MS2650/2660 series Spectrum Analyzer

Issue Number: WP-C5AZ02082917-00

Service Note

MISS ASSEMBLING OF EXTENDER CABLE

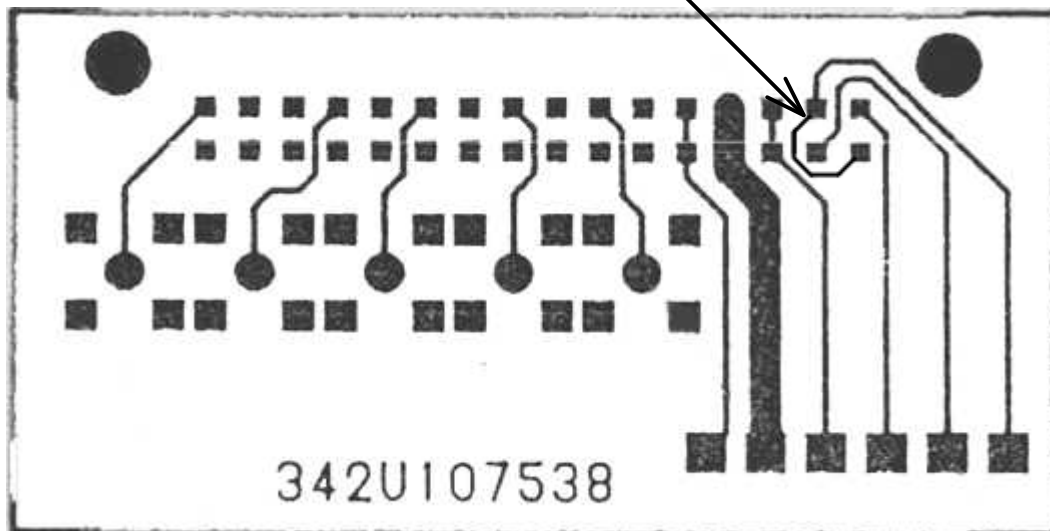
The extender cable mentioned above can not be used for 3GHz converter due to miss assembling.

Therefore 342U107538 PCB of the extender cables that have been delivered already, should be modified as below.

Short pin 1B and pin 2A with a wire.

Vibration of Fan

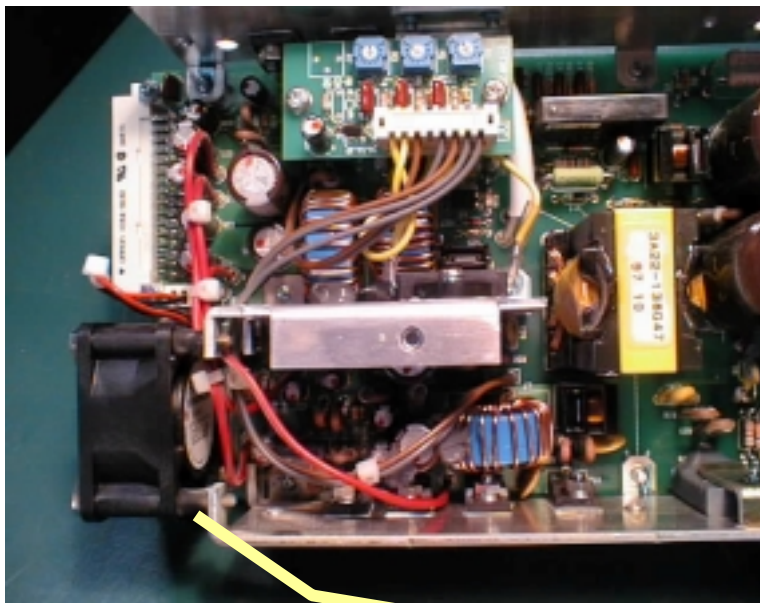
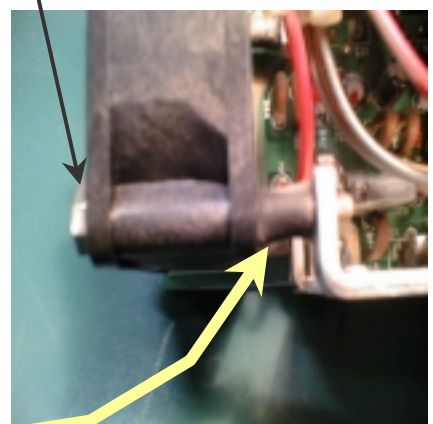
The vibration of the FAN (34Z112975 for power supply unit) is big.
Because the tightening of the screw was too strong (0.5kgfcm)
the vibration was transmitted to the package.

put the lock paints

Loosening (0.1kgfcm) the tightening of the screw and put the lock paints.
